Request for City Council Committee Action from the Department of Community Planning & Economic Development - Planning Division

Appeal of decision of the City Planning Commission: The Lander Group, on behalf of 3535 Grand II, LLC has filed an appeal of the decision of the City Planning Commission denying two setback variances for a proposed parking area accessory to a new multiple-family residential structure located at 3535, 3539 and 3543 Grand Avenue South in the R5 Multiple-Family District.

Appeal of decision of the City Planning Commission: Tran Muehller has filed an appeal of the decision of the City Planning Commission approving parking variances, setback variances and site plan review for a new multiple-family residential structure located at 3535, 3539 and 3543 Grand Avenue South in the R5 Multiple-Family District.

Staff report by Shanna Sether, BZZ-7112

FIRST FLOOR PLAN
1/16" = 1'-0"

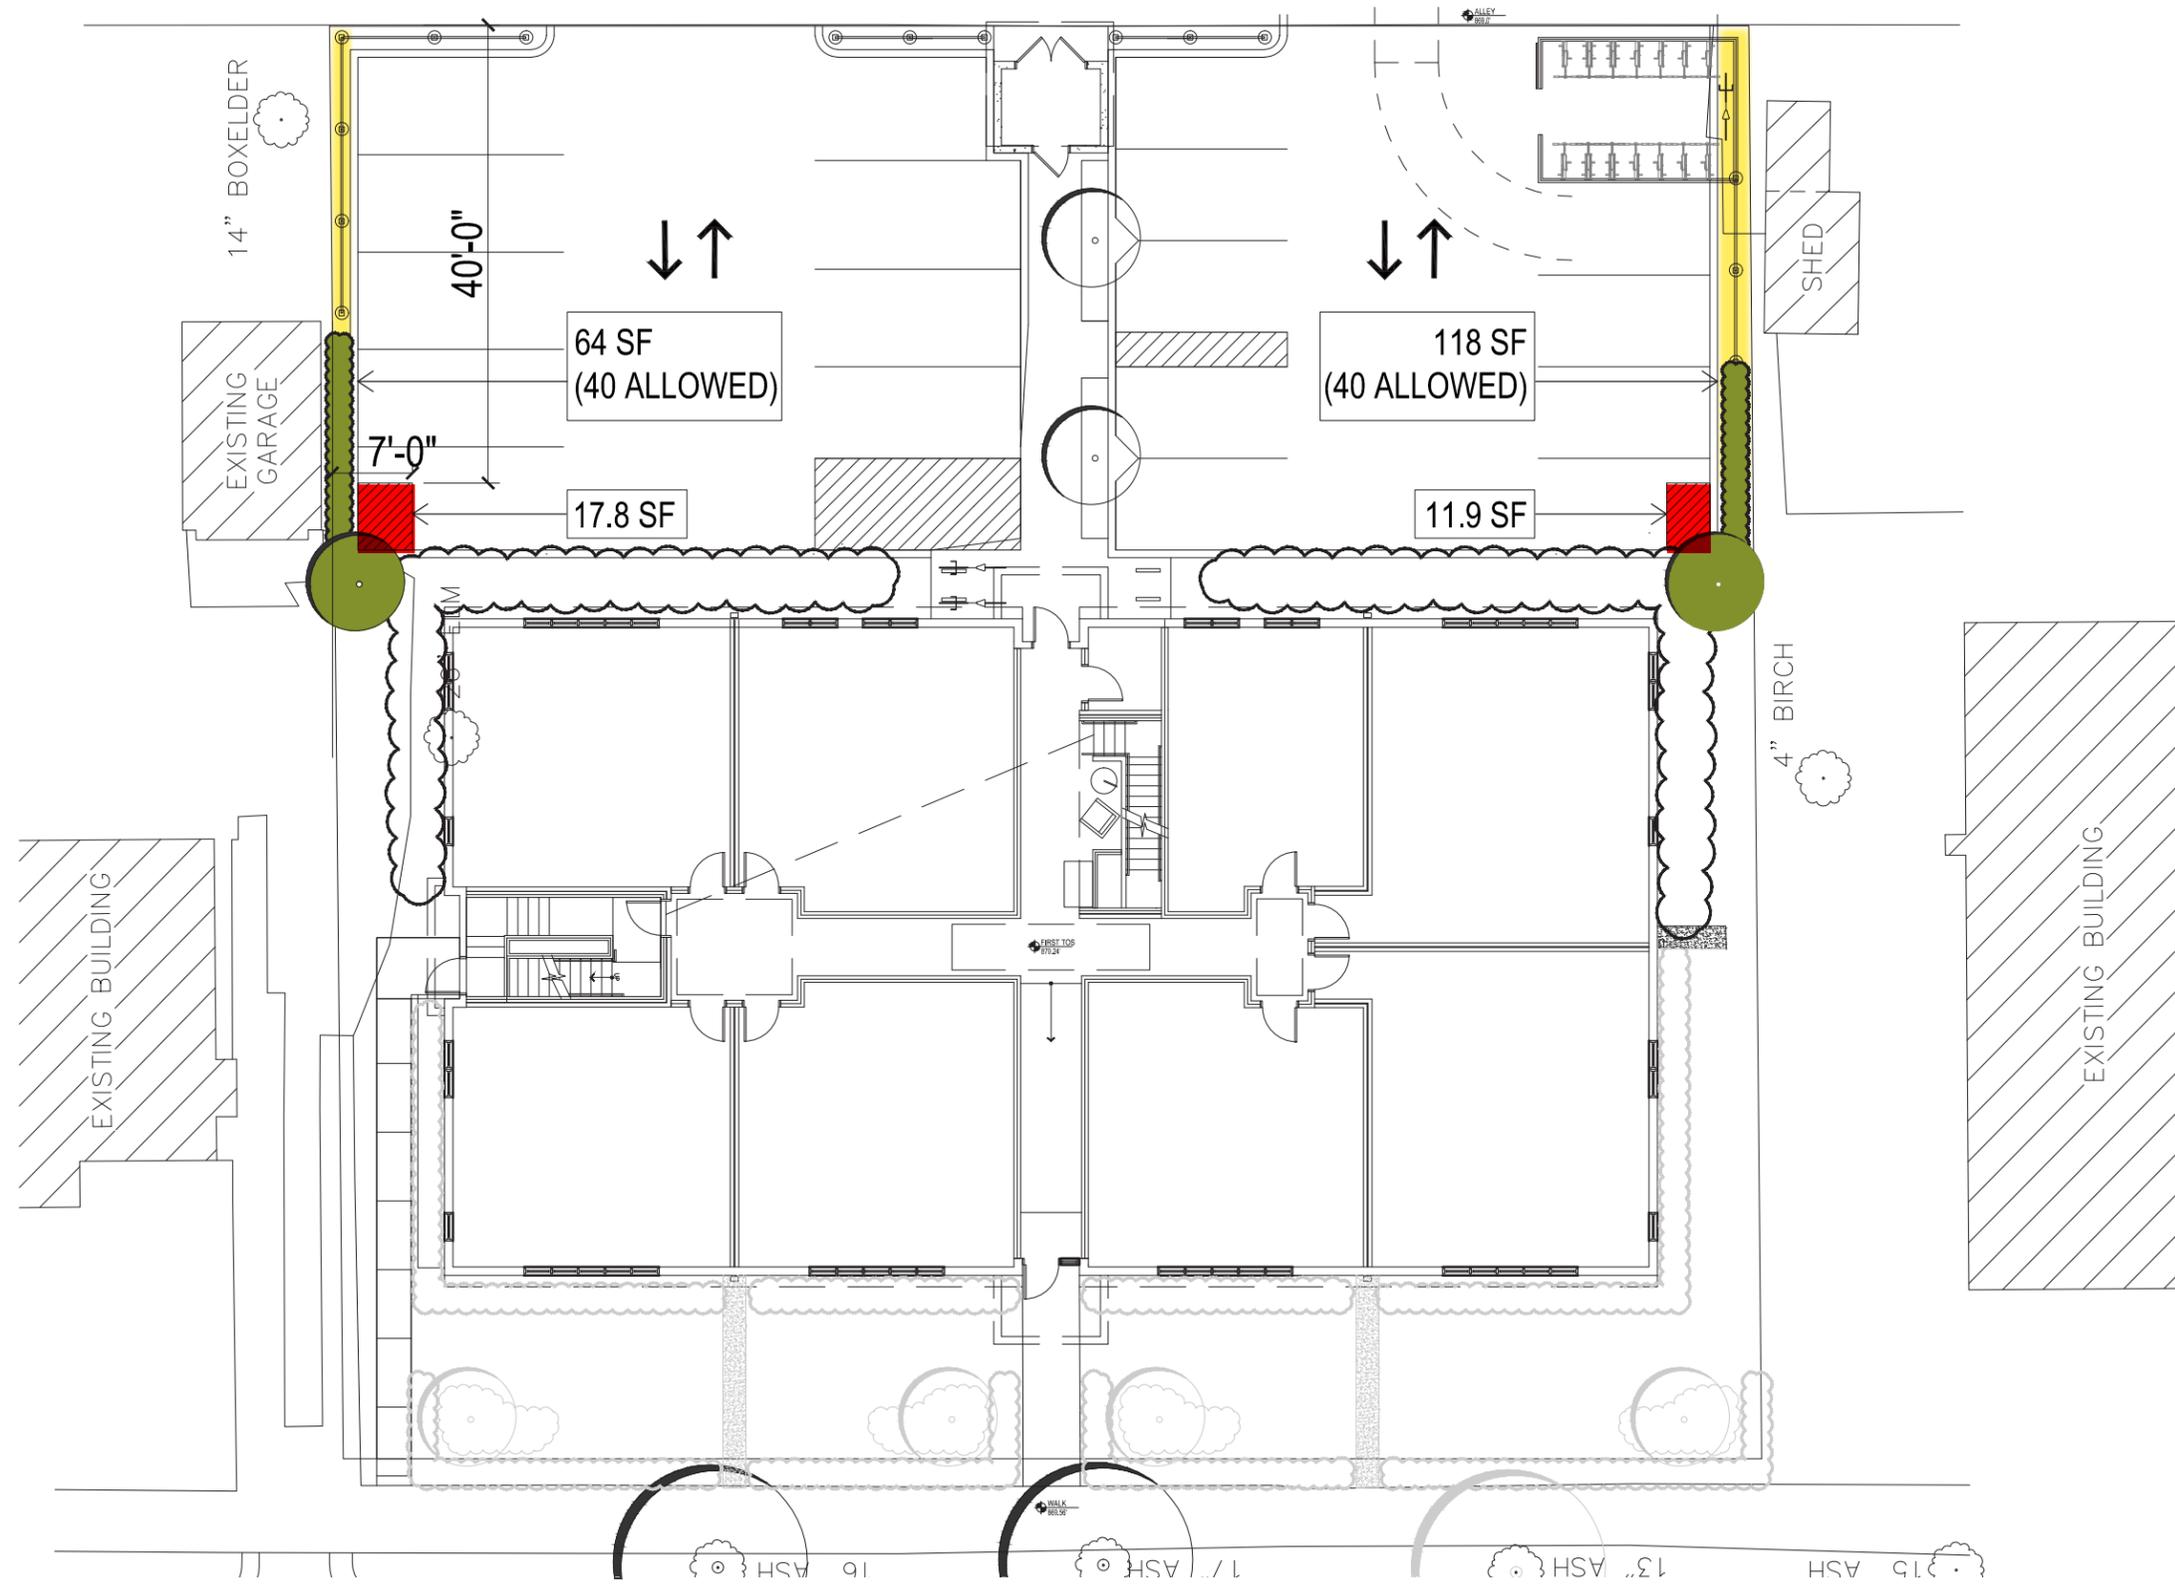
1. Parking Setback: Variance to reduce the setback on an interior side yard setback from 5' to 1'. The parking setback is proposed so that additional walk and planting area can be added in the middle of the site. This is done for ease of the residents getting to and from the trash in a convenient and safe manner. The additional area also provides the opportunity to get trees in this location.

- The parking is screened for the full length of the parking, and from the adjacent properties the extra 3' in setback proposed would not be visible.
- The applicant proposes to add two trees at the corner of the parking area as indicated on the attached diagram.

SITE PLAN

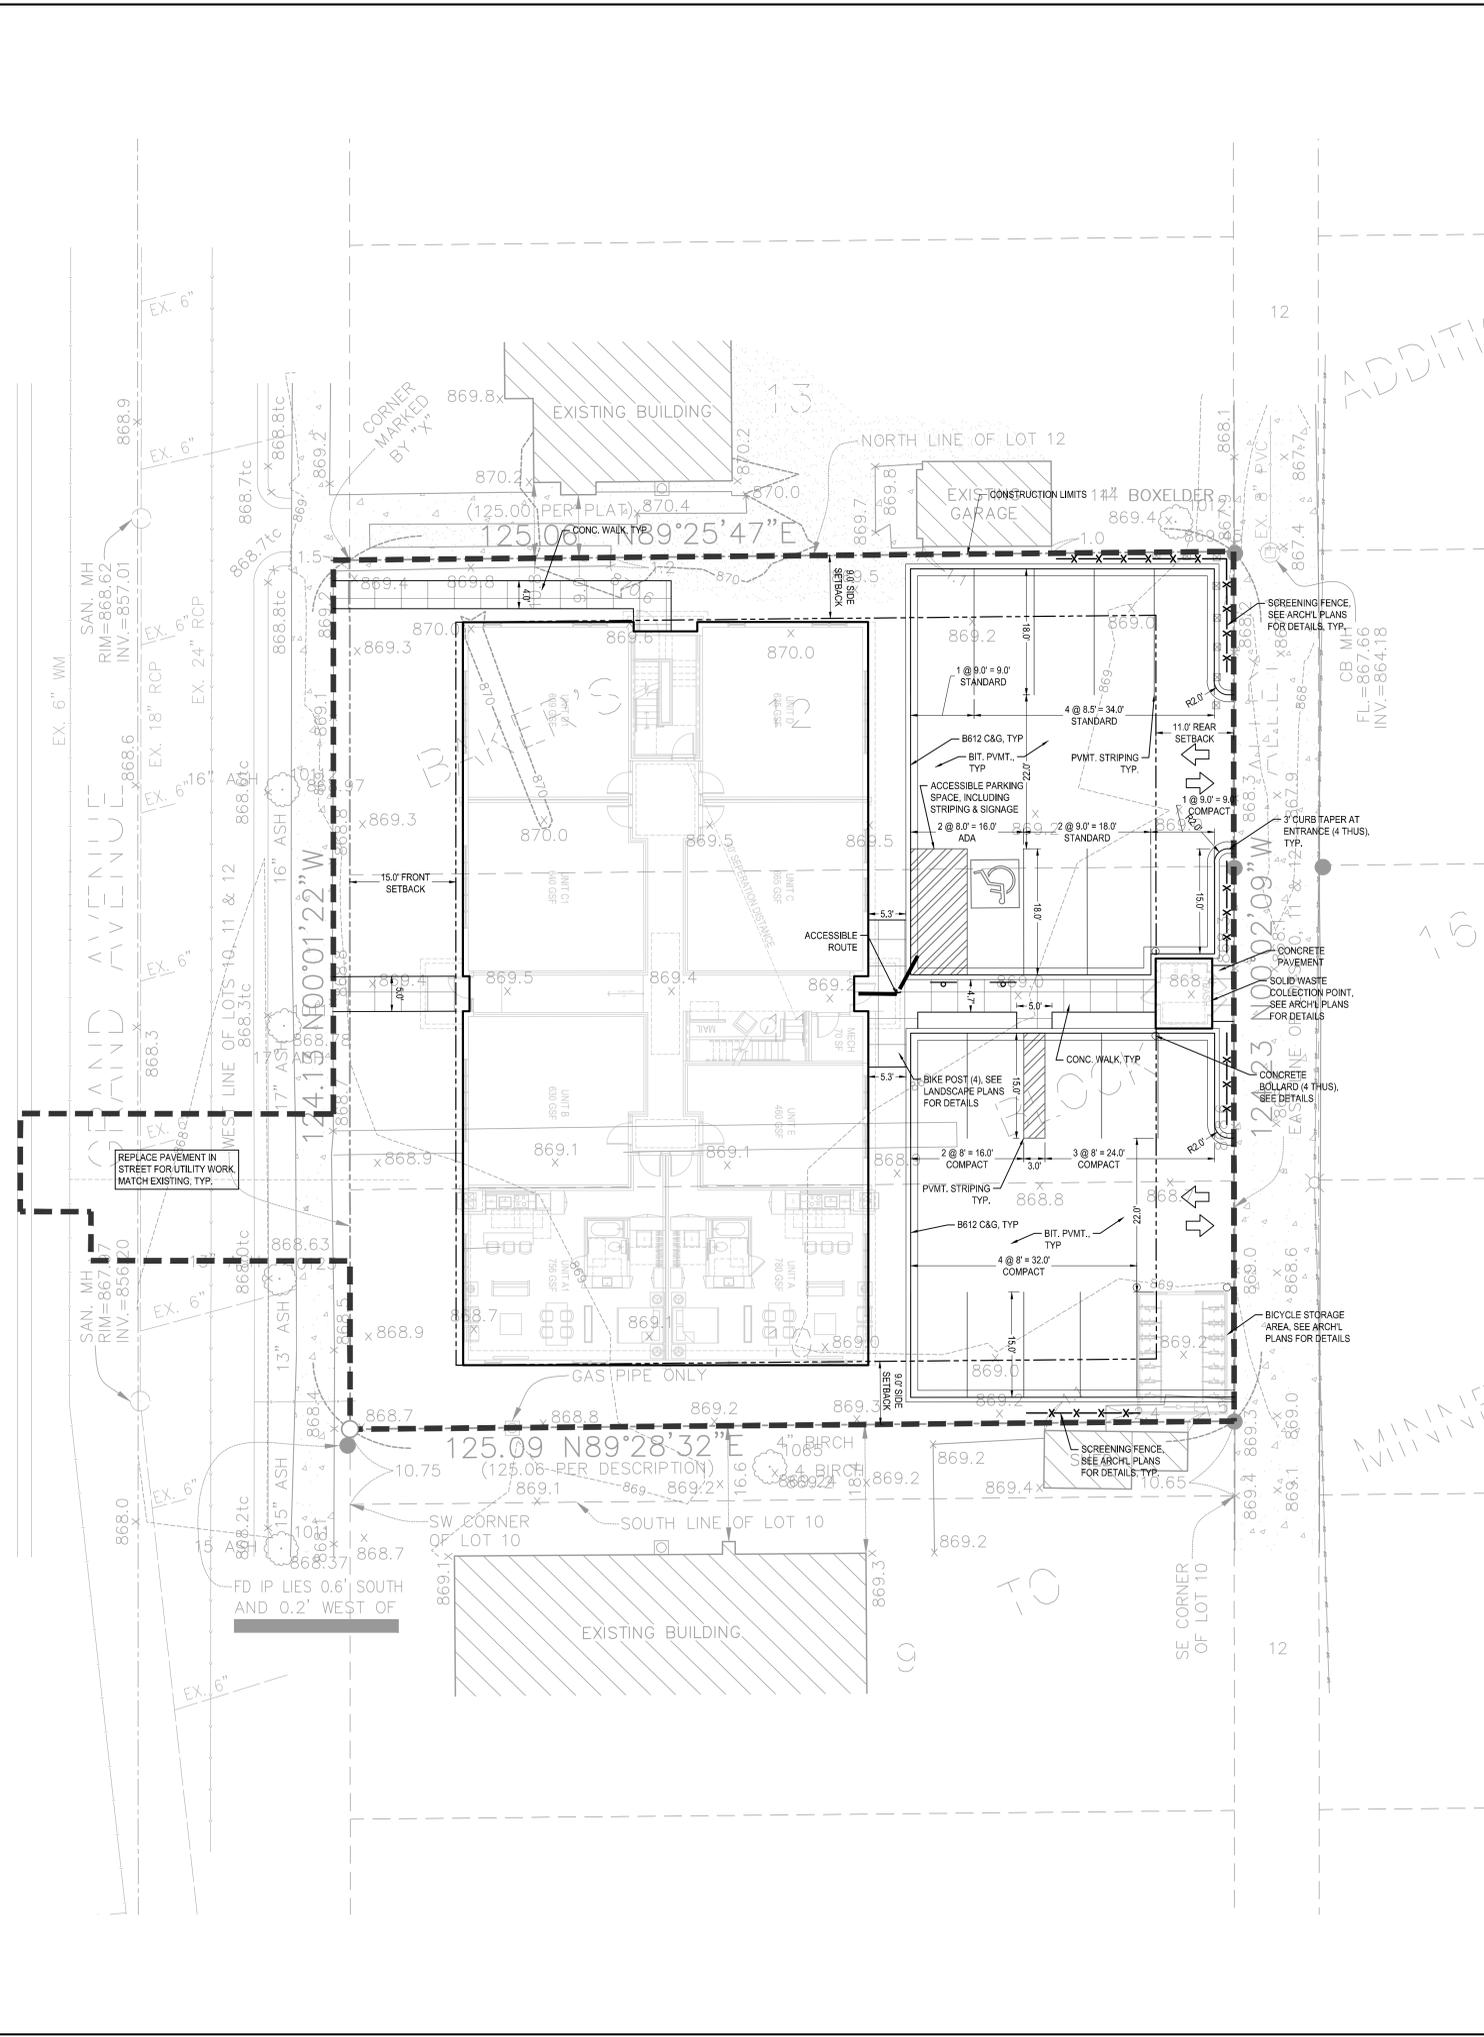
- A landscaped yard at least seven (7) feet wide shall be provided along the property line and alley. The applicant is proposing 2 feet of a landscaped yard at the north, 3 feet along the south and no landscaping along the alley. The applicant is seeking alternative compliance and has stated that it is impractical to provide additional landscaping and enough parking to support the proposed development. Staff recognizes the site constraints and recommends that the planning commission grant alternative compliance to requiring a 7-foot landscaped yard along the alley. However, staff finds that the applicant has the ability to reconfigure the walkway and co-locate the trash enclosure with the bicycle storage to allow for a minimum of a 5-foot landscaped yard. This will require the elimination of one off-street parking stall.

- The plan as submitted meets the requirements of the Public Works Traffic & Parking Services Division.
- Note to the Applicant: the parking lot and access to the Public alley appears to be very constricted; it is recommended that turning maneuvers for all vehicles types that will be using the parking lot be shown on the plans.
